Area 22 & 23, St Leonards South
26-50 Park Rd, 27-47 Berry Road, 48-54 River Road

RESPONSE TO COUNCIL RFI

Area 8 Section across Canberra Ave

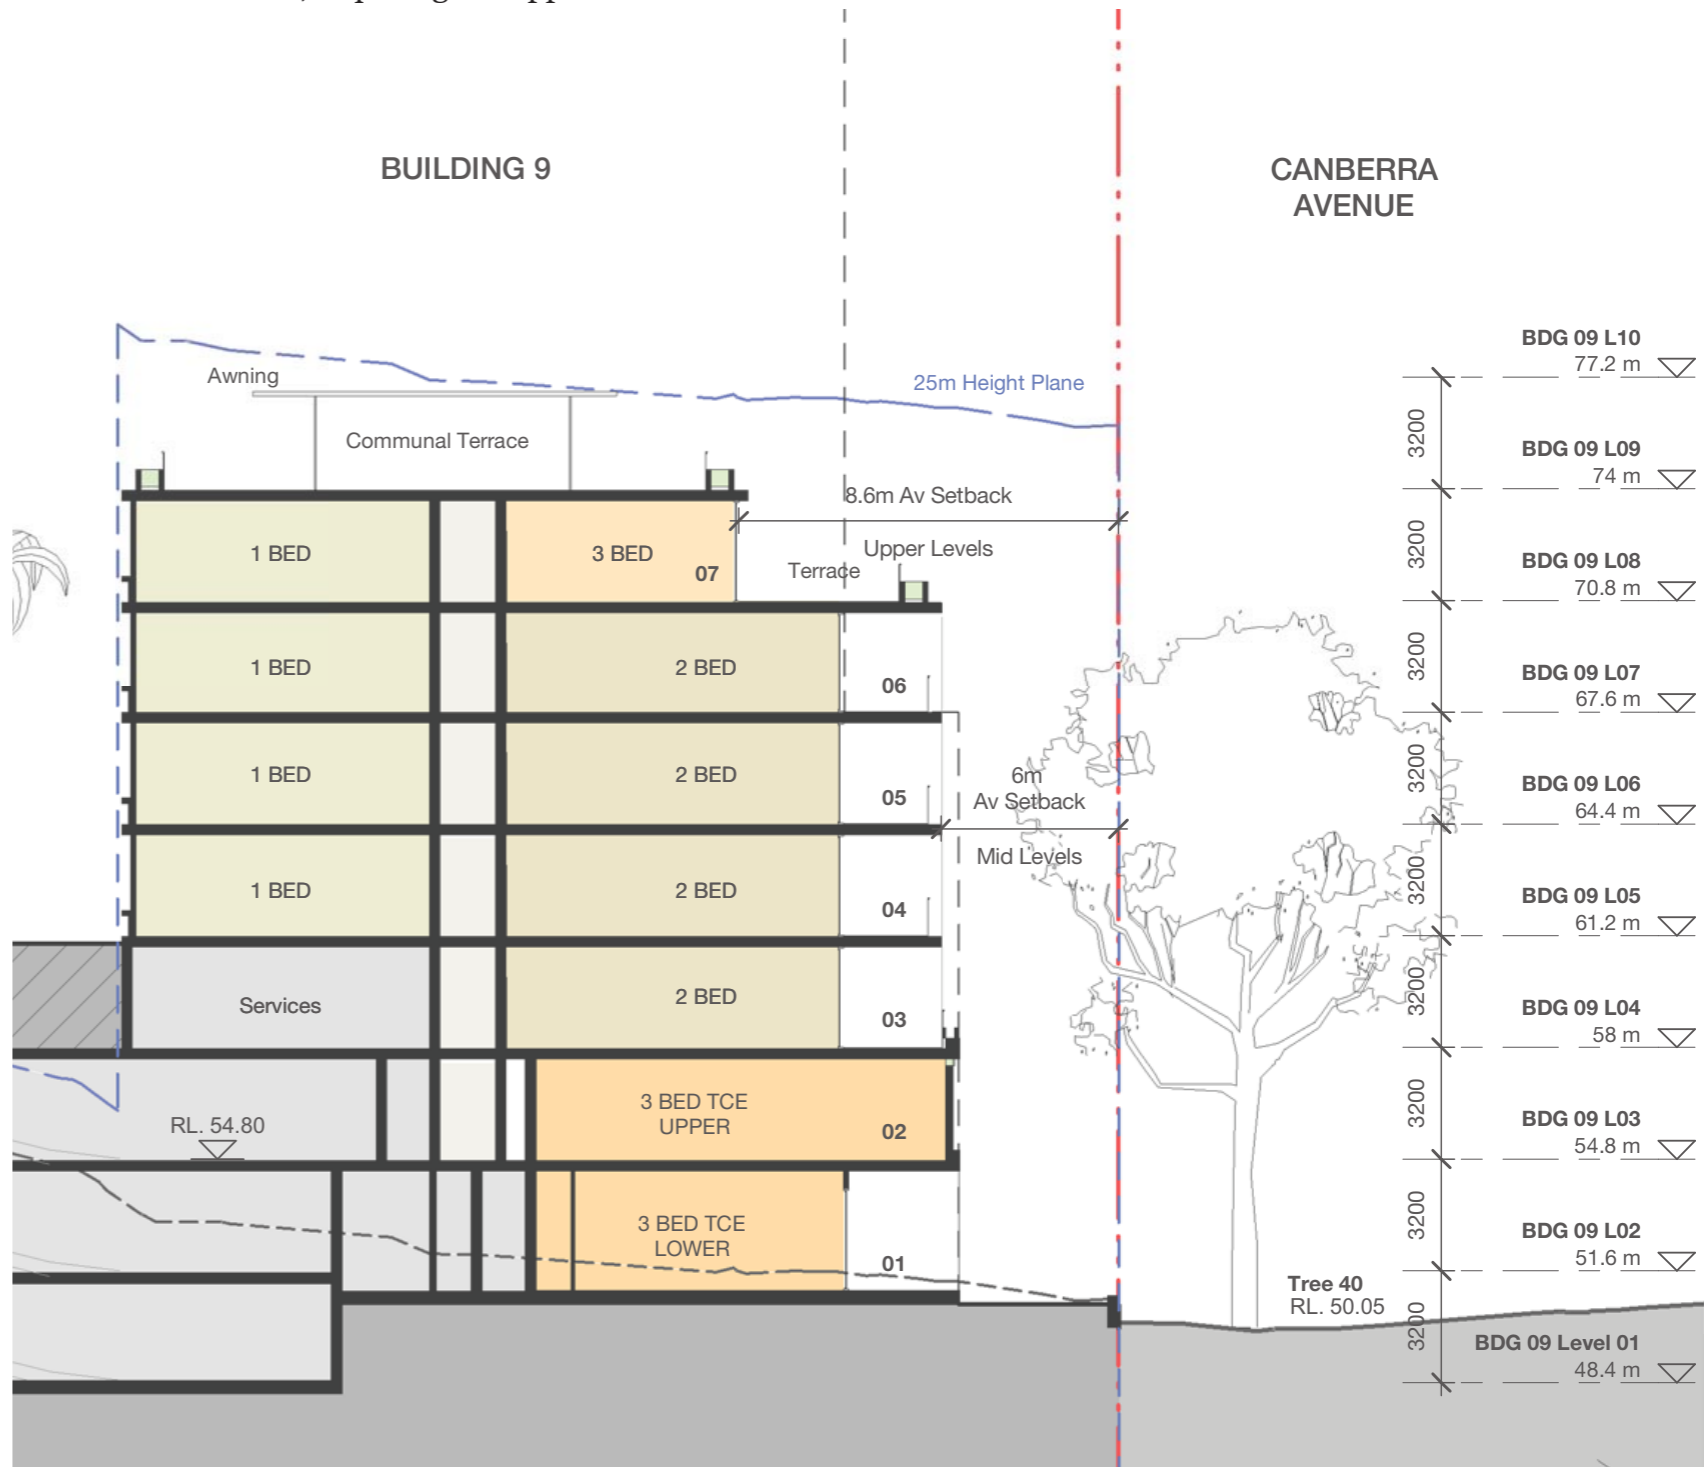
In reviewing the approval for Area 8, the officer assessment report, it states that the proposal complies with the then DCP amendment 20 on part storeys. The diagram illustrates that Council has in effect excluded the part storey in the tectonic of considering setback compliance. Our proposal adopts the same methodology which should equally be applied in terms of setback compliance, otherwise Area 8 would have deemed to have a breach of the DCP control, requiring the upper level setback to occur one level below that shown.

AREA 20 RIVER ROAD ELEVATION

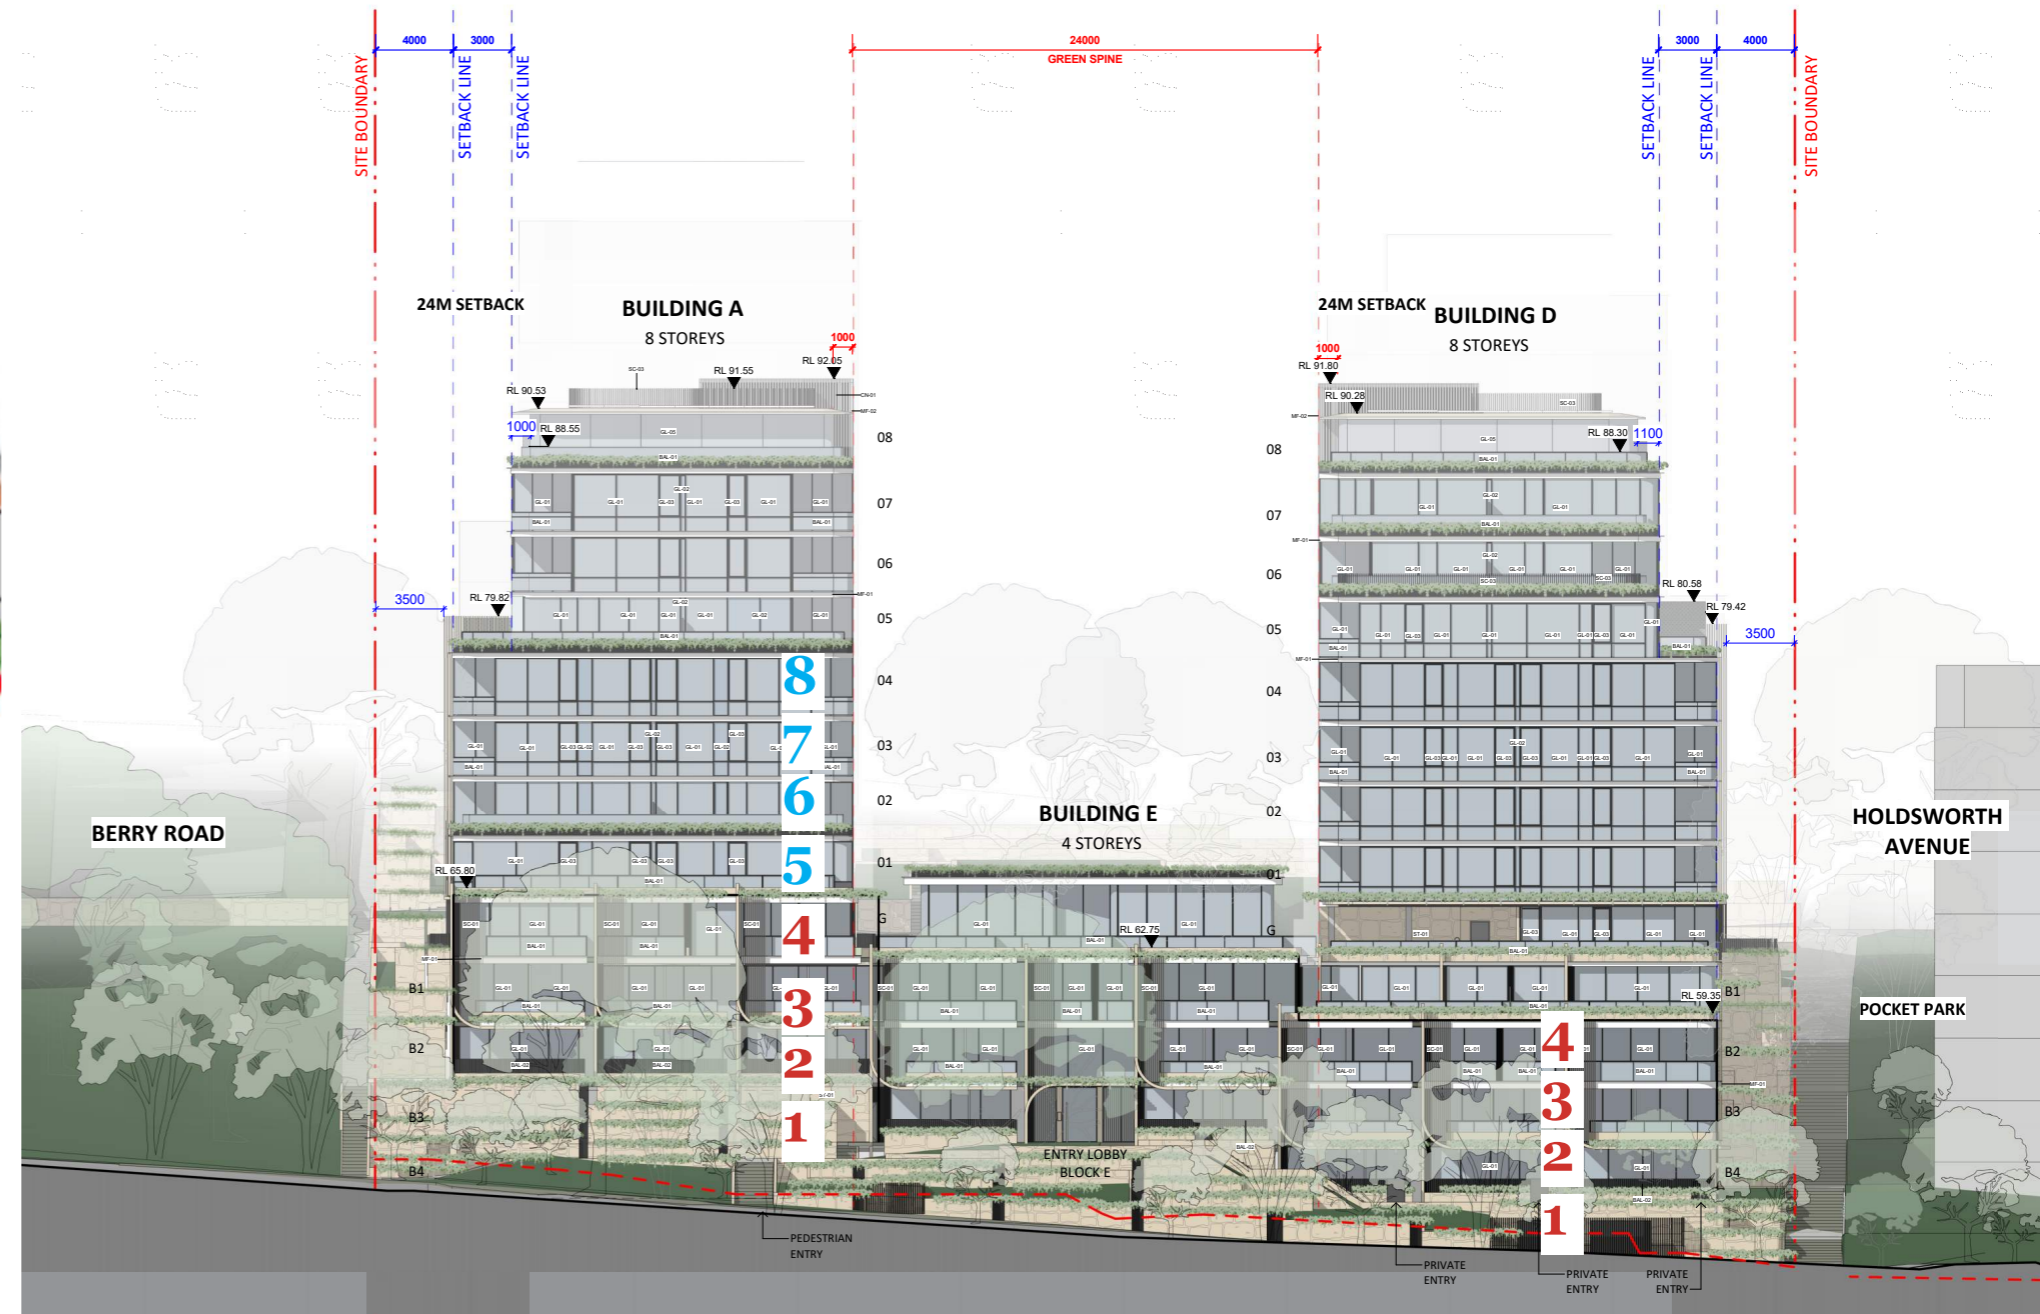
The Council assessment report by Council stated the building fronting River Road was compliant in terms of the setback controls, which incorporated part storeys. This results in a physical increase of 1-2 storeys above the street level translating in an increased 'actual' street height built form.

By incorporating part storeys along this frontage, our proposal is consistent and thus the same methodology should be adopted by Council.

Our proposal archives a superior outcome however with active residential use at ground level as opposed to blank walls.

AREA 20 HOLDSWORTH AVE ELEVATION

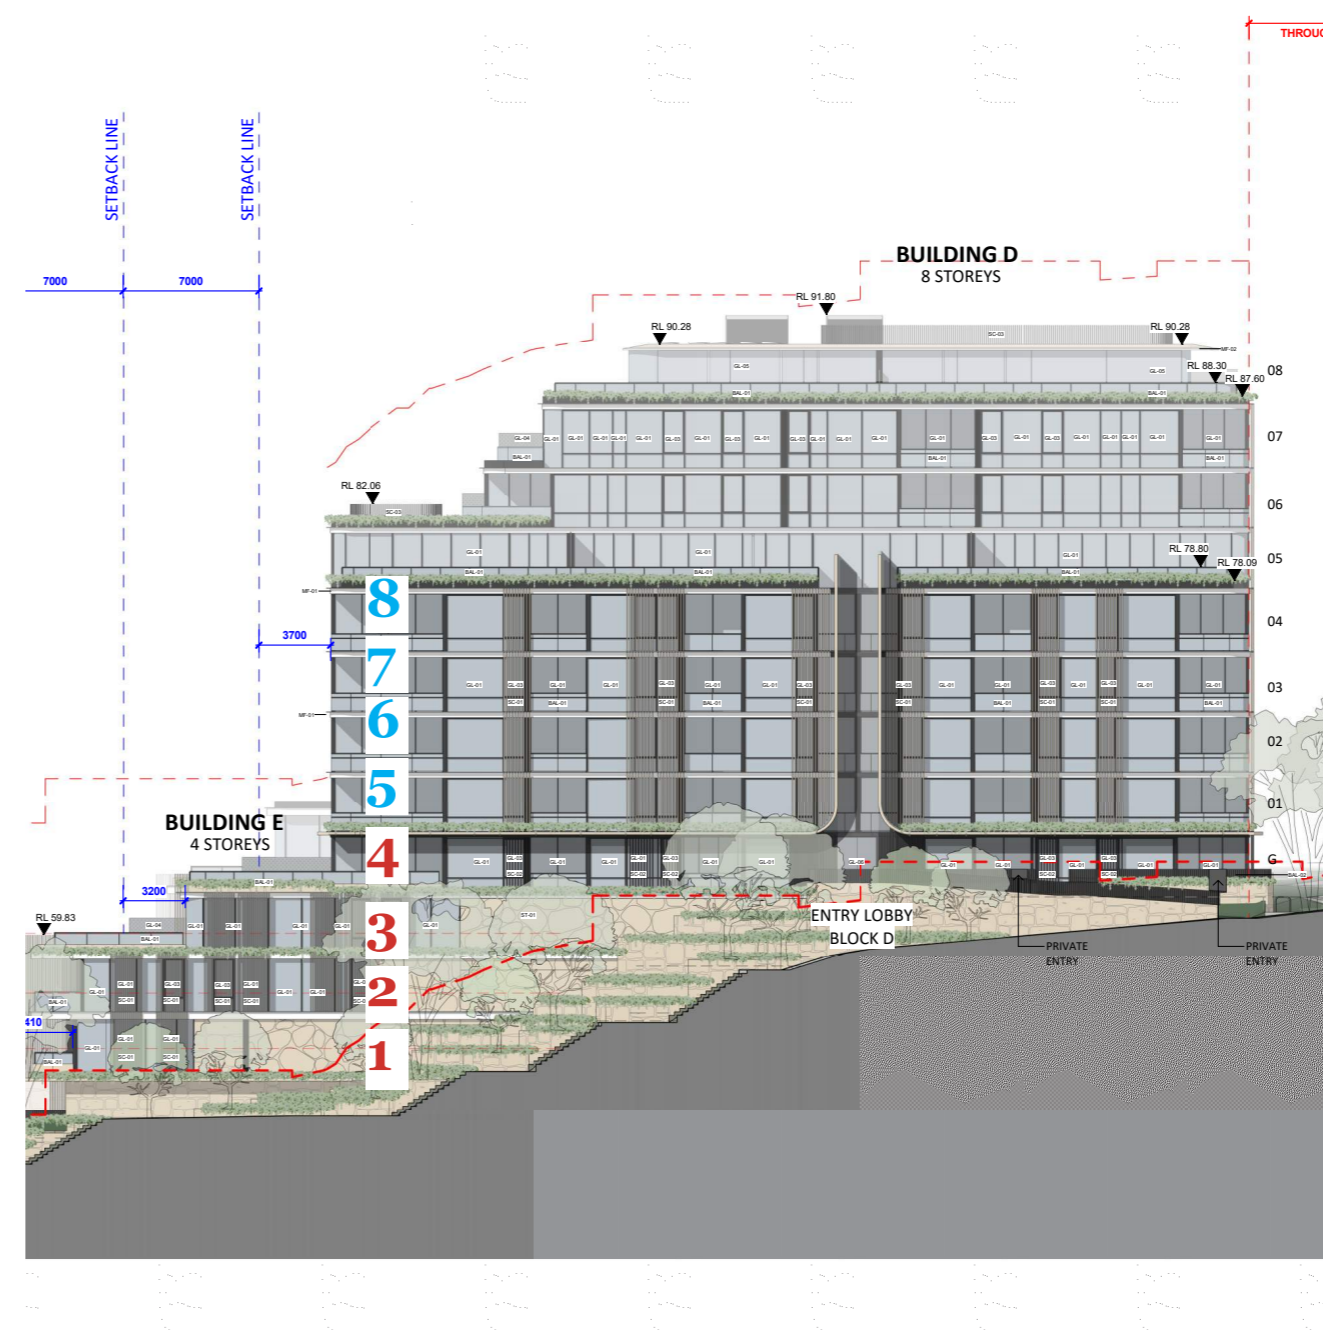
The Council assessment report by Council stated the building fronting River Road was compliant in terms of the setback controls, which incorporated part storeys. This results in a physical increase of 1-2 storeys above the street level translating in an increased 'actual' street height built form.

By incorporating part storeys along this frontage, our proposal is consistent and thus the same methodology should be adopted by Council.

Our proposal archives a superior outcome however with active residential use at ground level as opposed to blank walls.

Council Comment (Building D)

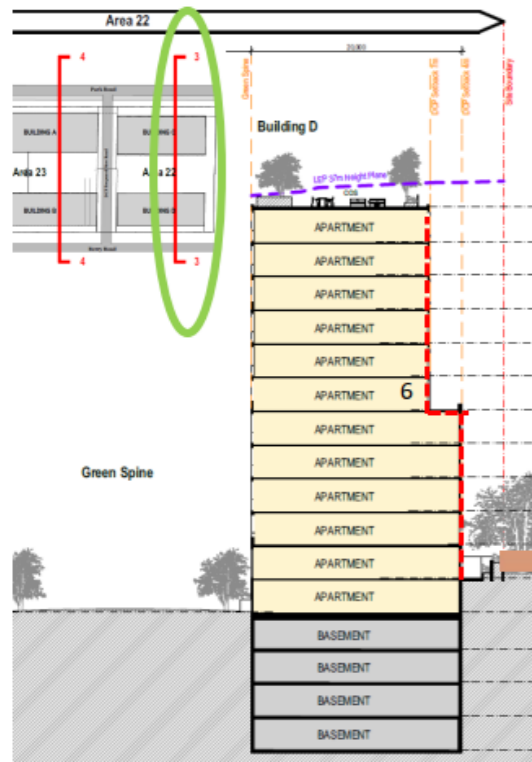
The proposed building setbacks do not comply with the DCP requirements at the following areas:

- DCP proposed New Road (Building D) 7m setback at level 6;
- DCP proposed New Park (Building D) 9m setback at level 5

The height in storeys has a minor non-compliance owing to the sloping nature of the site and the need to provide rationale floor plates. As a consequence elements of the street wall height marginally exceed the storey count and in some instances they fall below the DCP level. So the variation is justified on the grounds of the design responding to the sloping topography and adopting an average weighted approach, on balance, the proposal meets the intent of the control and thus represents an appropriate response.

Furthermore, Council has accepted an average weighted approach when supporting the front setback variations on the Area 7-11 project.

Council Comment (Building D)

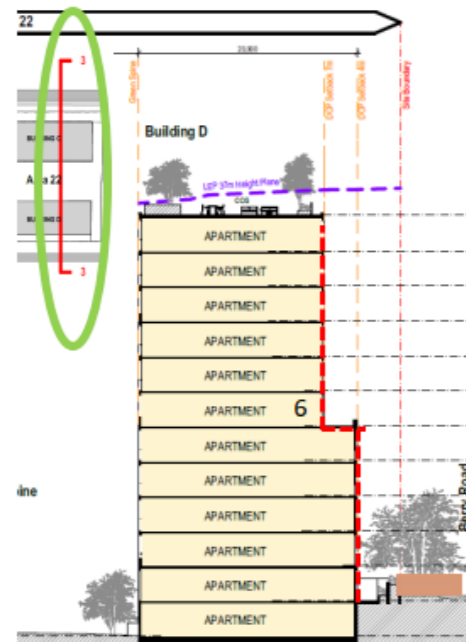
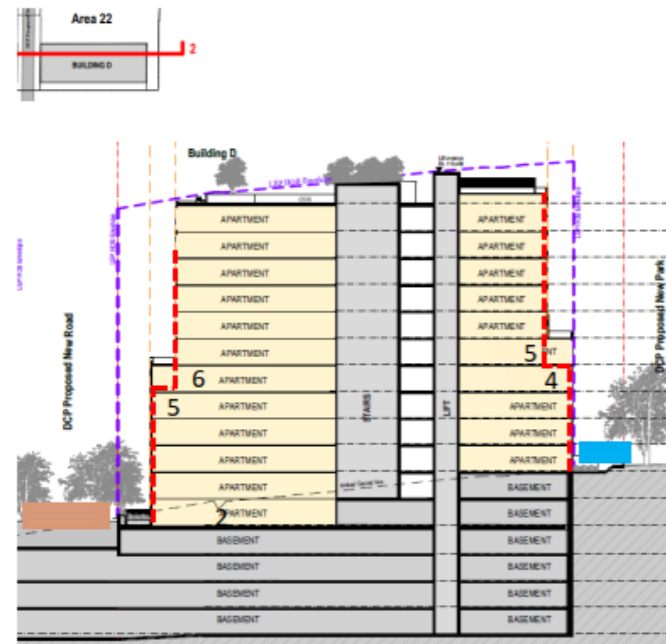
The proposed building setbacks do not comply with the DCP requirements at the following areas:

- DCP proposed New Road (Building D) 7m setback at level 6;
- DCP proposed New Park (Building D) 9m setback at level 5

The height in storeys has a minor non-compliance owing to the sloping nature of the site and the need to provide rationale floor plates. As a consequence elements of the street wall height marginally exceed the storey count and in some instances they fall below the DCP level. So the variation is justified on the grounds of the design responding to the sloping topography and adopting an average weighted approach, on balance, the proposal meets the intent of the control and thus represents an appropriate response.

Furthermore, Council has accepted an average weighted approach when supporting the front setback variations on the Area 7-11 project.

VIEW 01 - Building D - New Road & Berry Road - Proposed

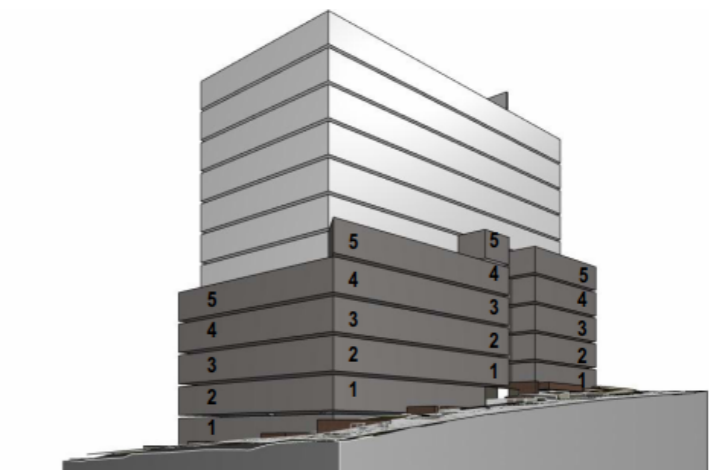
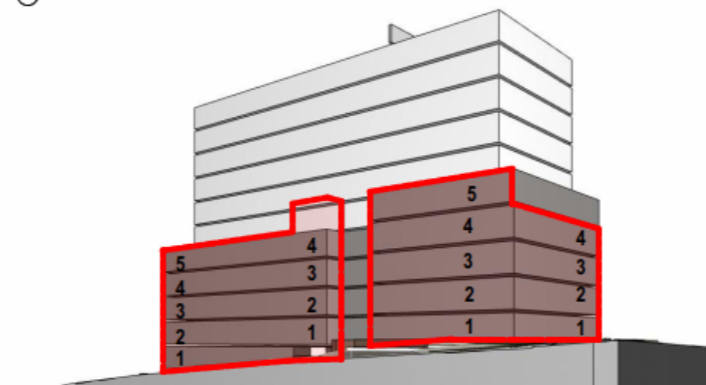
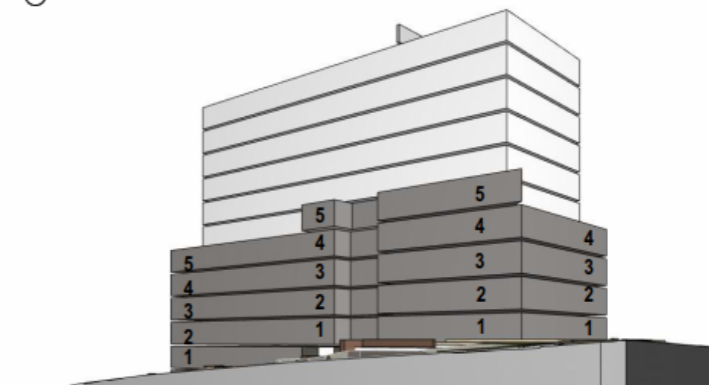
VIEW 01 - Building D - New Road & Berry Road - DCP Setbacks

VIEW 02 - Building D - New Park & Berry Road - Proposed

VIEW 02 - Building D - New Park & Berry Road - DCP Setbacks
